Technical Service Bulletin

**AIR CONDITIONER DOES NOT BLOW COLD AIR DUE TO CRACKED
COOLER PIPE (HI) A (REFRIGERANT LEAK)**

Bulletin No.: 07-004/18

(1)	Cooler pipe (HI) A
(2)	A/C compressor
(3)	Condenser

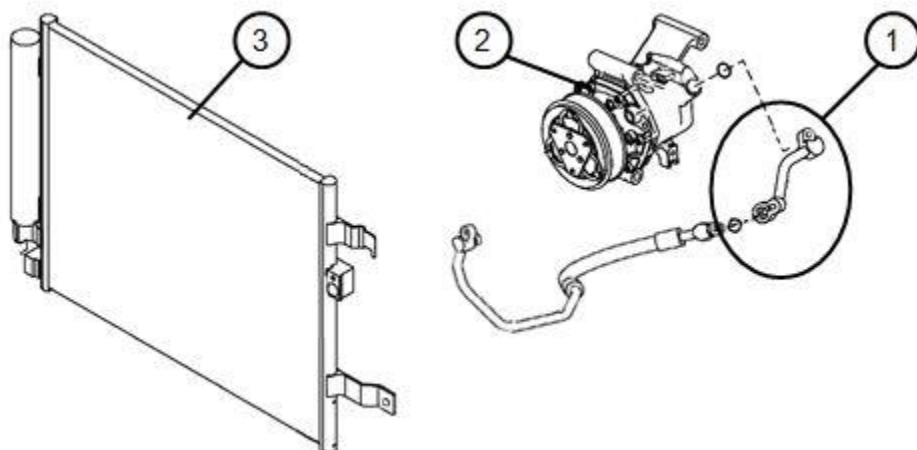
Some vehicles may experience that the A/C does not blow cold air (blows warm air) due to a refrigerant leak. This is caused by a crack in the cooler pipe (HI) A (1) due to engine vibration. To correct this issue, the material and thickness of the cooler pipe (HI) A has been changed to increase durability.

1. Verify customer concern.
2. Inspect the cooler pipe (HI) A.
 - If the cooler pipe (HI) A is cracked, replace the cooler pipe (HI) A with a modified one according to the instructions on MGSS (REFRIGERANT LINE REMOVAL/INSTALLATION).
 - If the cooler pipe (HI) A is not cracked, this TSB is not applicable. Refer to troubleshooting procedure on MGSS (NO COOL AIR [CLIMATE CONTROL SYSTEM]).
3. Verify repair.
